## FOUNTAIN HEAD GOLD PROJECT

### SUPPLEMENT TO THE ENVIRONMENTAL IMPACT STATEMENT

NOVEMBER 2021

FIGURE 5.1

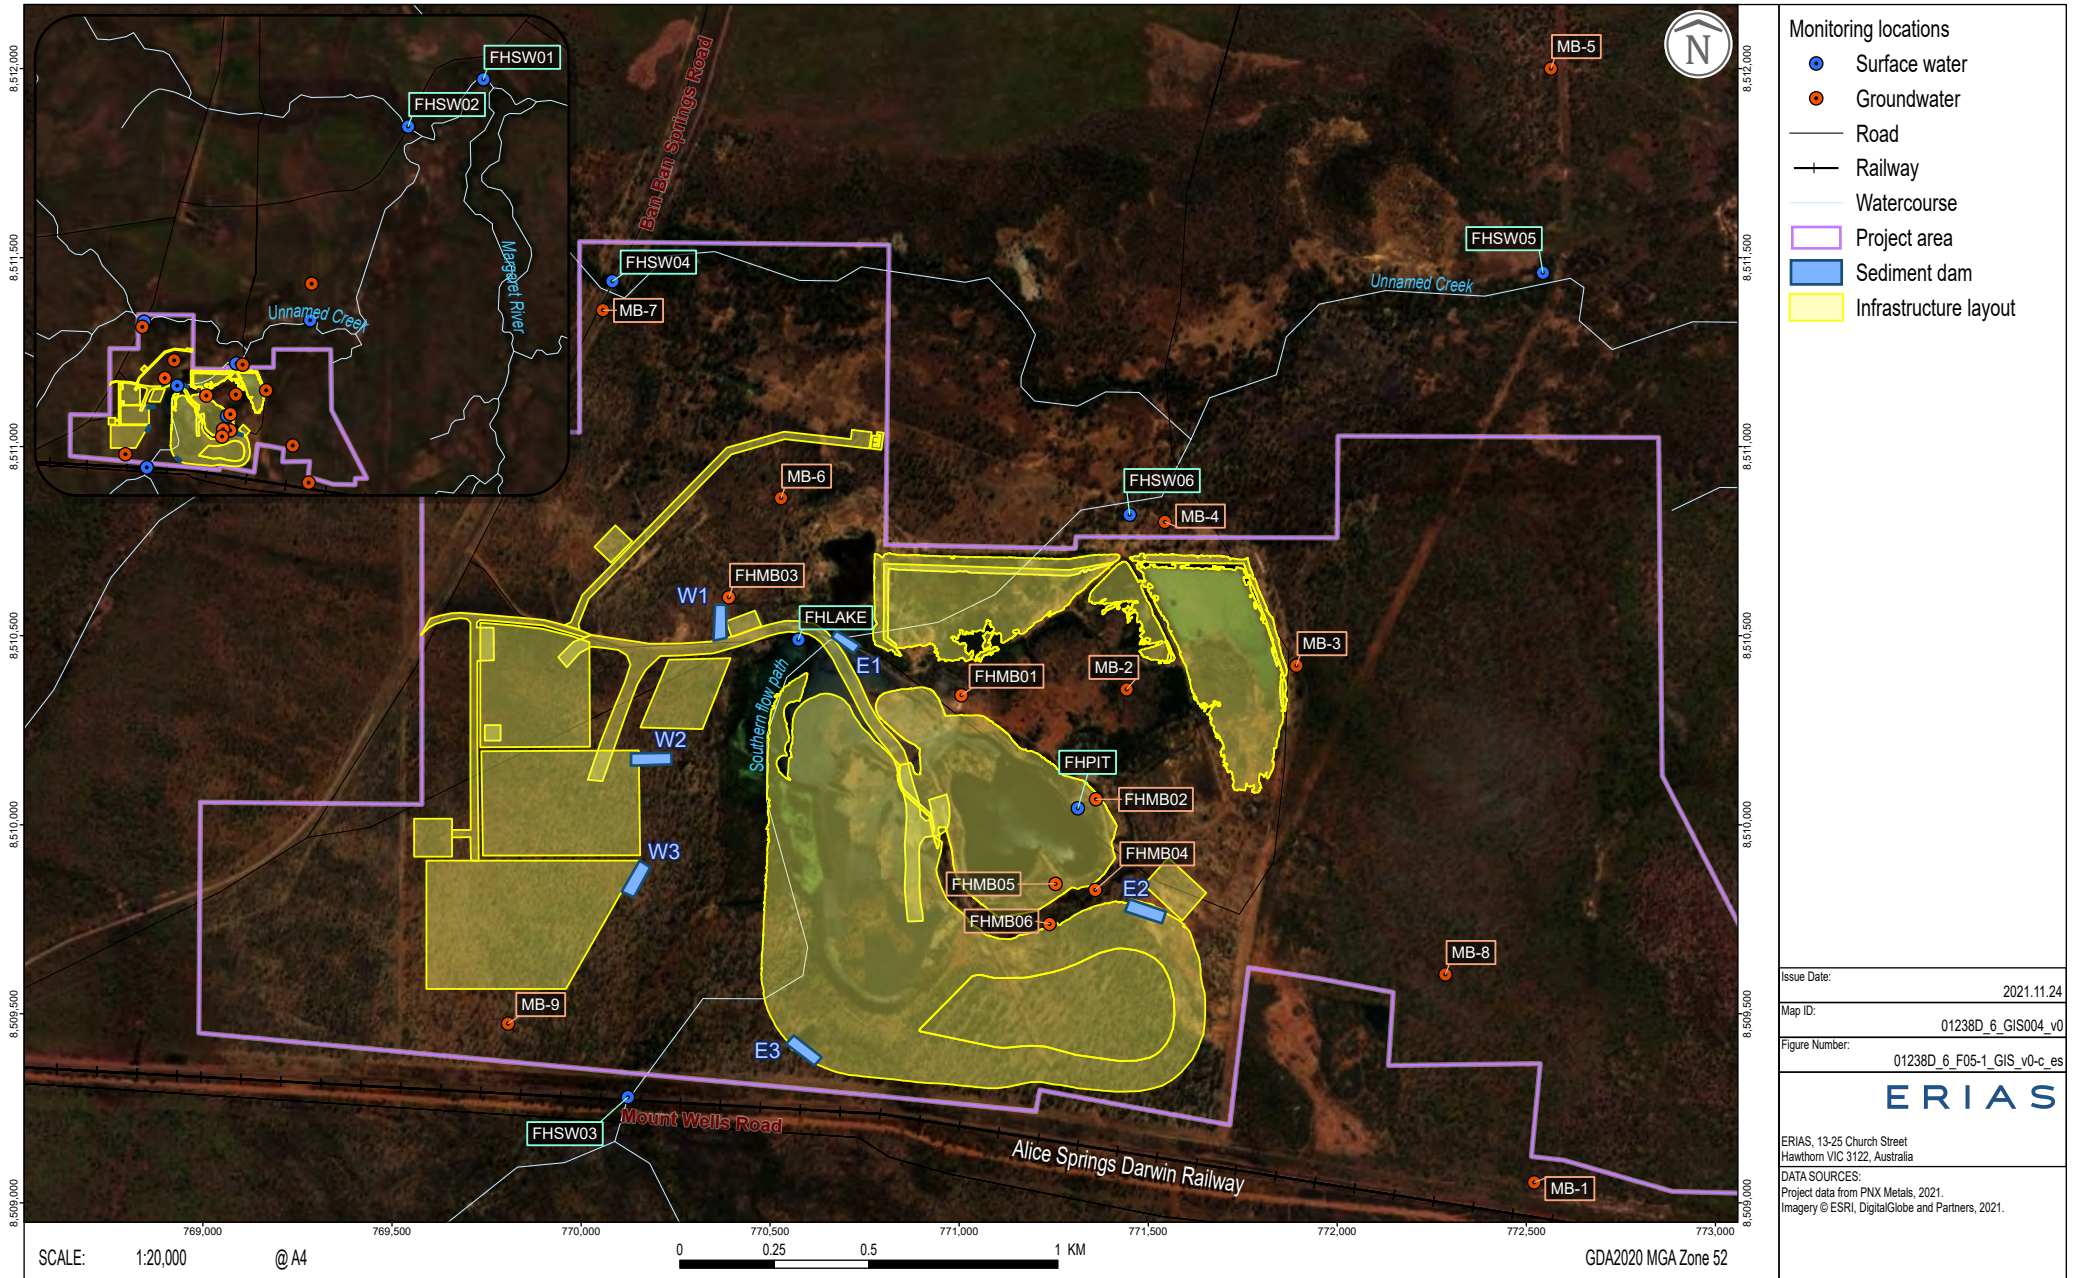
The groundwater monitoring network has been revised in the updated WMP and the analytical suite has also been expanded. Groundwater results will be compared to the livestock drinking water guidelines provided in Table 7.6 of the updated WMP and to the aquatic ecosystems guidelines provided in Table 7.4 of the updated WMP (noting that consideration of naturally elevated metals and metalloids such as arsenic and aluminium will be required). The monitoring and contingency measures outlined in the updated WMP describe how the identified objectives will be met and corrective actions/triggers that will be undertaken if required.

The updated WMP has been revised to include two additional surface water monitoring sites immediately downstream of the Project area (FHS05 & FHS06) in the unnamed tributary creek (Figure 5.1). Monitoring at FHSW06 will provide an indication of surface water quality leaving the site, and FHSW05 will provide an indication of water quality once the water leaving the site has mixed within the unnamed tributary creek immediately downstream. It will also provide a comparison to surface water quality at FHSW04, just upstream of the site.

FIGURE 5.2

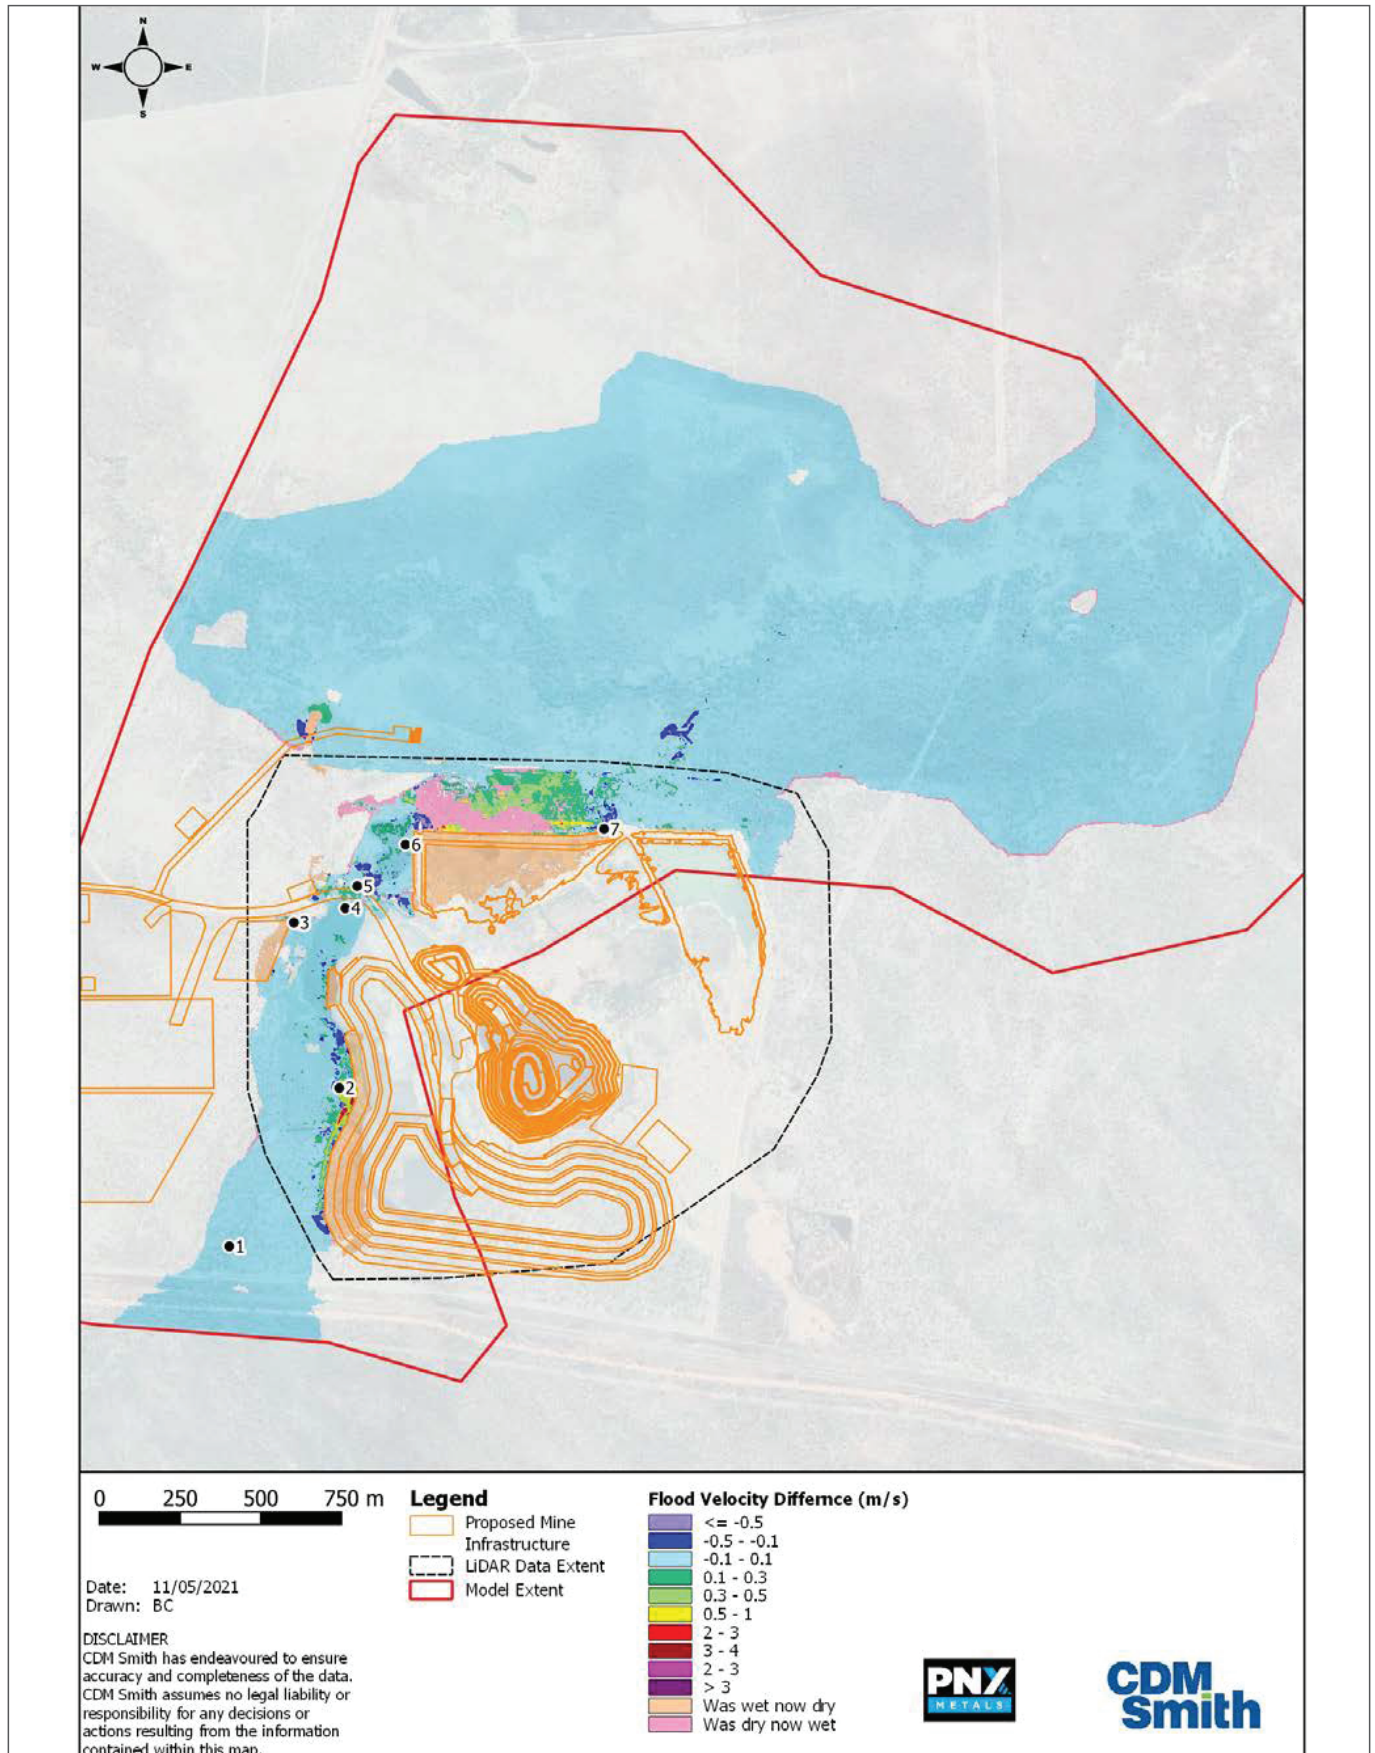
Provide information for source material for erosion protection and diversion structures.

Erosion protection and diversions (based on the channel) are proposed along the western side of the IWL to protect the structure and allow the natural catchment runoff from upstream of the processing area to divert around the IWL and around the north of the evaporation pond. The flood modelling shows that the outer toe, based on locations 2 and 4 in Figure 5.2 will experience peak flood levels of 0.05 to 1 m and velocity differences of approximately 0.5 to 1 m/s. As flood levels and velocities are low and as the IWL is constructed of competent rock, impacts are not expected. Rock armour will be applied along the western side of the IWL utilising competent waste rock from the pit.
